playhouse.design.group
1916 23RD AVE SOUTH, SEATTLE WA

DESIGN REVIEW RECOMMENDATION
1436 NW 62ND ST, SEATTLE WA
DPD # 3015381 | AUGUST 11, 2014

REVISED STREET LEVEL FACADE TREATMENT

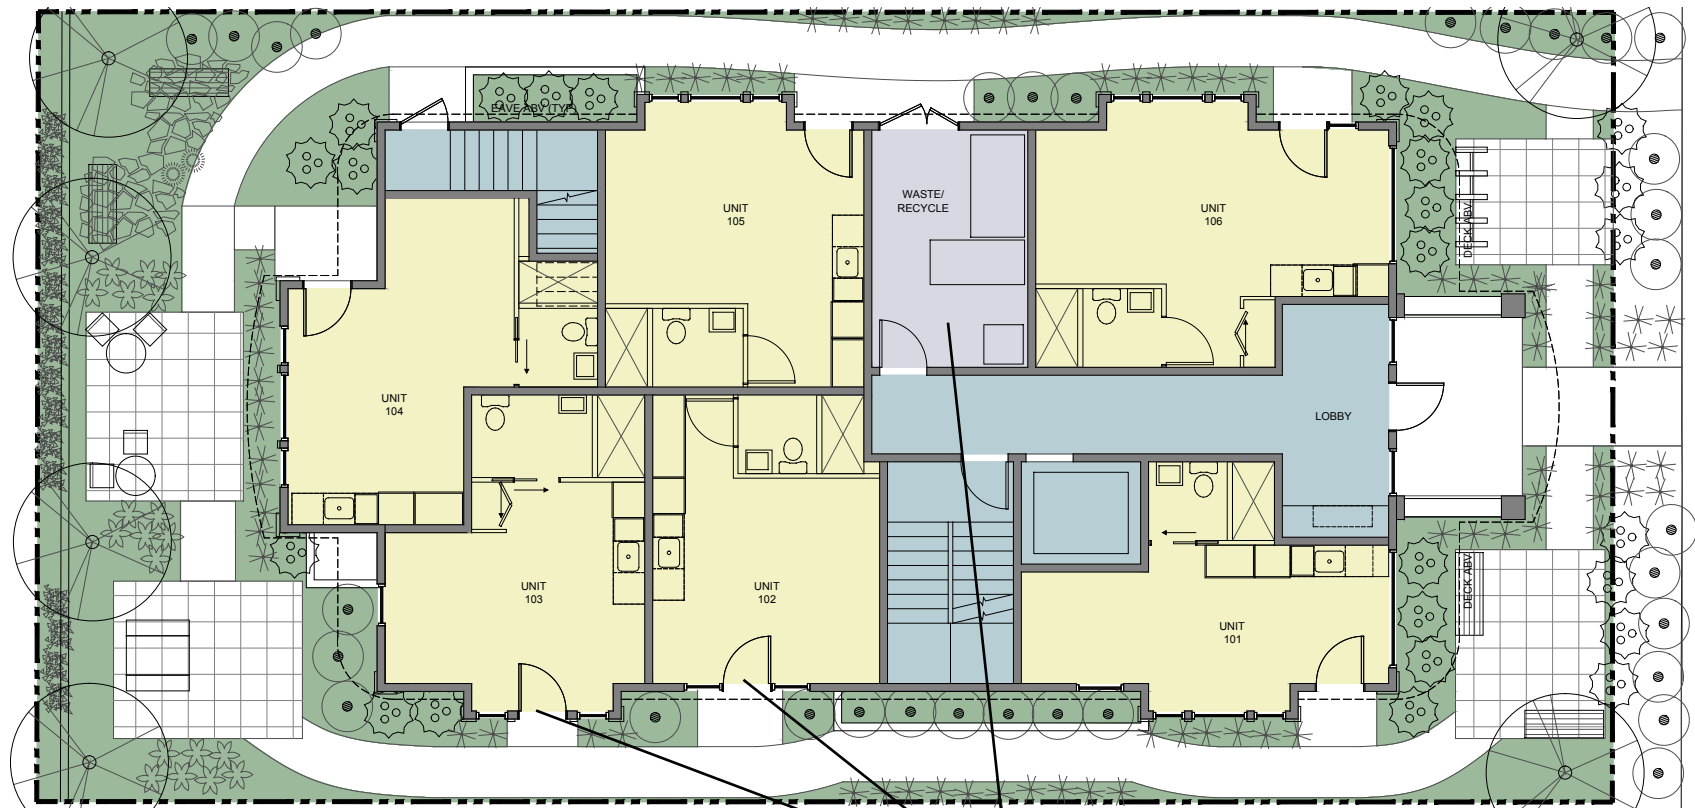
1. NW 62nd Street Façade

The Board noted that most of the buildings along NW 62nd Street are three stories tall creating a consistent street wall context.

- a) The Board agreed the 4-story massing and architectural concept should be informed by the existing 3-story street wall context. The Board suggested including a stronger horizontal datum line with an upper level setback at the fourth floor level (A-2).

5. Materials

The Board noted the building exterior should be constructed of durable materials.

- a) The Board encouraged the use of materials found in residential buildings. The Board also encouraged the use of light, warm materials to maximize light reflectivity, and wood to provide a finer grain of texture (C-4).

We added an eave to the fourth floor level, which is similar to the one at the 2nd floor level, in order to draw the eye to the lower 3 stories while de-emphasizing the upper floor. The eaves are proposed to be a brighter color than the rest of the building to further draw the attention away from the fourth story. In addition, the top floor will be a gray color to help mute its appearance. This results in a perceived smaller scale of the building.

Eave Added at 4th Floor Line

Muted gray HardiPanel at upper story

Light colored plank siding on 3 stories

Painted blue eaves draw the eye away from the upper story

Light colors are used on the majority of the building to maximize the reflected light into neighboring properties. Light colored, finer-grained texture on the lower 3 stories will create a warmer, more welcoming feel and bring the building down to a more relatable scale. Materials used are Hardi-panel & 12" Hardi-plank, wood trim, metal railings, and wood decking.

REVISED GROUND FLOOR AND SITE PLAN

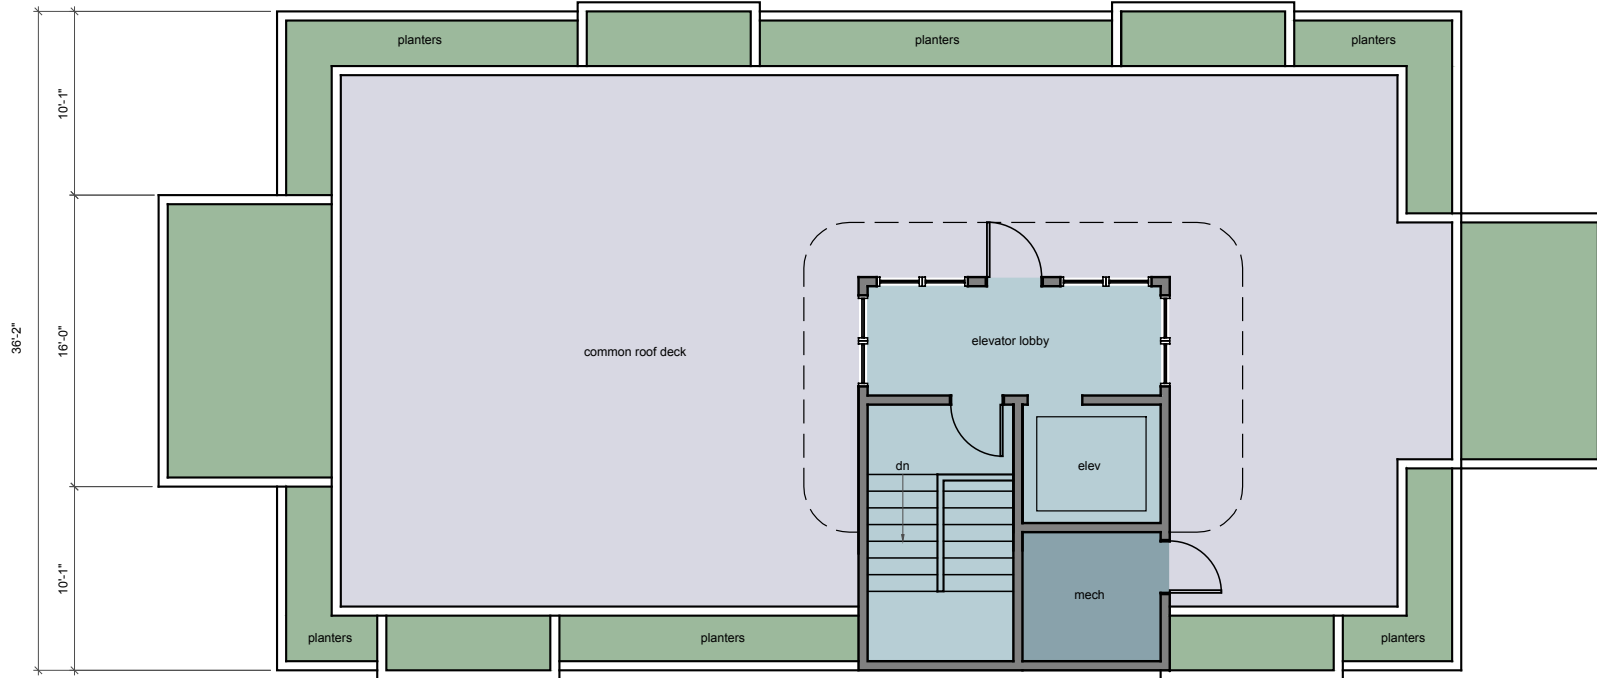
2. Open Space programming (ground floor)

The development is surrounded by existing residential units on three sides: north, west and east. The Board agreed that the amenity space location and programming requires additional attention in order to minimize noise impacts on adjacent residential uses.

a) The Board would like to see open space maximized at the ground level rather than on the roof. The Board requested info and a design that shows how the ground level open spaces will be programmed at the recommendation stage (A-5, A-7).

3. Trash and Recycling

The Board felt the response to guidance provided at EDG was not adequately addressed. The Board agreed the intensity of the development, with 27 units, warranted locating the solid waste and recycling within the building to minimize noise and odor impacts on adjacent residential units.

a) The Board encouraged the applicant to re-examine the ground floor plan. The Board noted the building corners are more appropriate for residential units which allow direct access to open space and windows openings on two sides. The Board felt building support services, including solid waste and recycling storage space should be located mid-façade to minimize the travel distance to the street for pickup (A-1, D-6).

b) The Board agreed relocating the solid waste within the structure will allow additional amenity space opportunities at ground level and will minimize noise and odor impacts on adjacent residential units (A-5, A-7 and D-7).

4. Side Setback Treatment

The Board would like to see the 5' side setback maximized to create a great walkable environment with extensive vegetation.

a) The Board felt the pedestrian walkway width should be minimized to provide a greater depth of landscaping buffer. The Board noted the landscaping may vary location to create visual interest, while also functioning as screening at key locations along the property line and adjacent to ground level windows (A-7, D-7).

b) The Board encouraged the applicant to include direct connections between the ground level units and the walkways provided at the perimeter of the site. The Board felt the direct access would create more livable ground level units, create a sense of ownership of the setback space, and provide more eyes on the setback (A-7, D-7).

c) The Board would like to see more landscaping throughout the site, particularly at the perimeter and on the roof (E-2).

Waste/Recycle Location with plantings opposite entry
 Level 1 unit entries located off side setback

For the ground level amenity, there are different outdoor 'rooms' with chairs and tables, separated by plantings to make them feel more intimate. There will be plants acting as a screen along the rear fence to give more privacy to the North Neighbors.

The trash and recycle is now located in an interior room midway along the length of the building, where it will be fully screened from view and odors may be contained. This also allows more ground floor amenity area for tenants to enjoy.

The ground floor units are now accessed directly from the side setbacks instead of an interior courtyard, which will encourage the tenants to maintain the space outside of their unit. Curving walkways with plantings on either side will screen views while providing an interesting pedestrian experience thru the site.

REVISED ROOF DECK PLAN

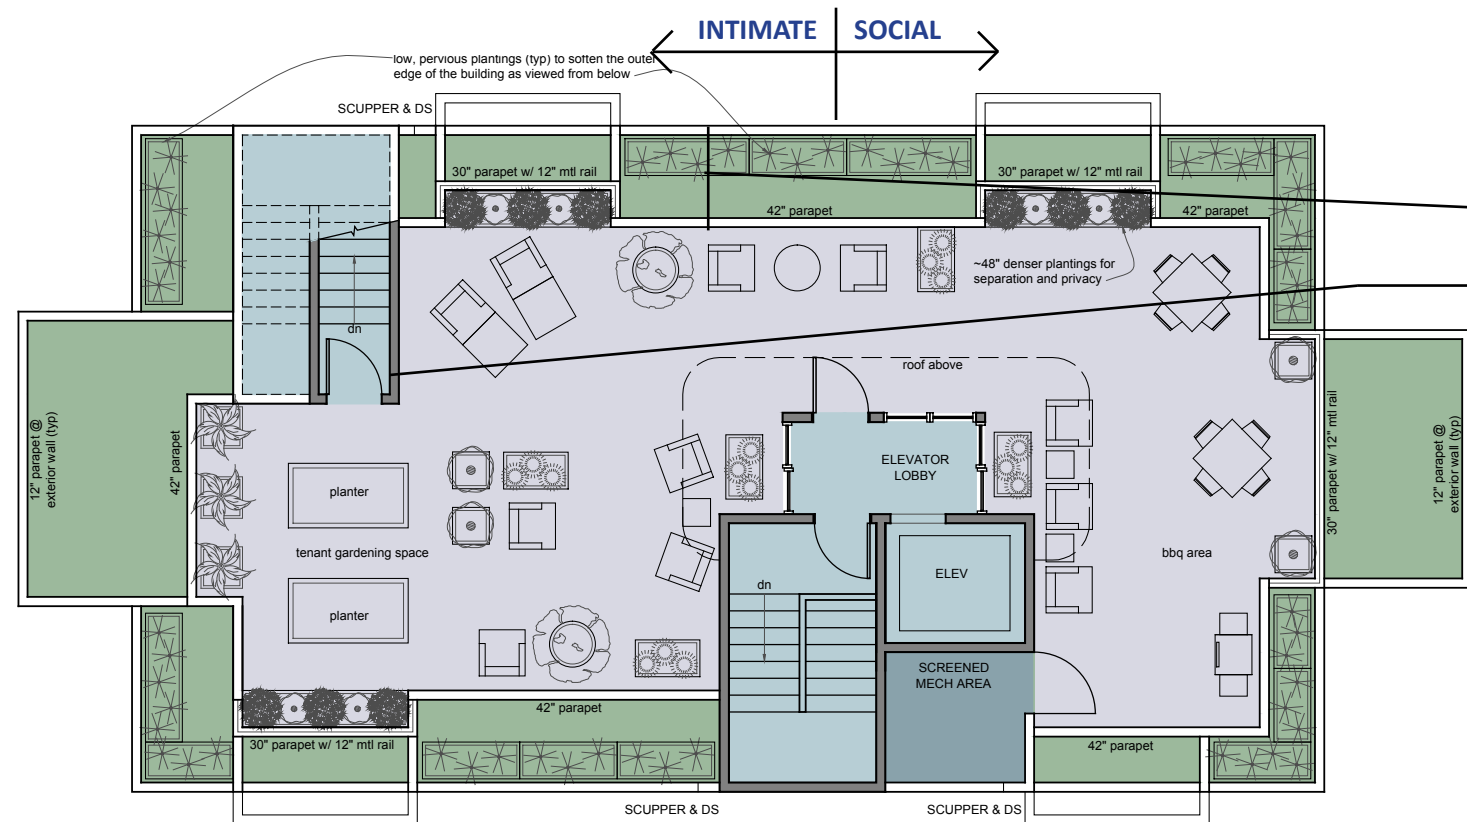
2. Open Space programming (roof deck)

The development is surrounded by existing residential units on three sides: north, west and east. The Board agreed that the amenity space location and programming requires additional attention in order to minimize noise impacts on adjacent residential uses.

- b) The Board requested a developed roof deck design to encourage day uses generating less noise, such as urban agriculture. The Board felt programmed gathering places should be located to minimize noise impacts to adjacent residential units (A-5, A-7).
- c) The Board requested more information about the planting proposed at roof level. The Board felt the landscaping provided at the perimeter of the roof deck should be designed and irrigated for minimal maintenance (A-7, E-2).

We moved the parapet railings in further from the building's edge and decreased the total area of the roof deck. It is programmed to keep the North part of the deck as a quieter area because it's closer to the neighbors. This is done by locating a tenant garden space furthest North, with 1 or 2 chairs interspersed between planters in order to discourage larger gatherings. The South portion of the deck will have tables, chairs and a BBQ grill - the more social activities - because it's closest to the public street.

The parapet rail is raised to 42" in most places for greater privacy from neighboring buildings. There will be planters scattered around the deck to help absorb sound and to create smaller seating areas.

Deeper planters along the building edge

Secondary stair tower creates more separation from the neighbor to the North.
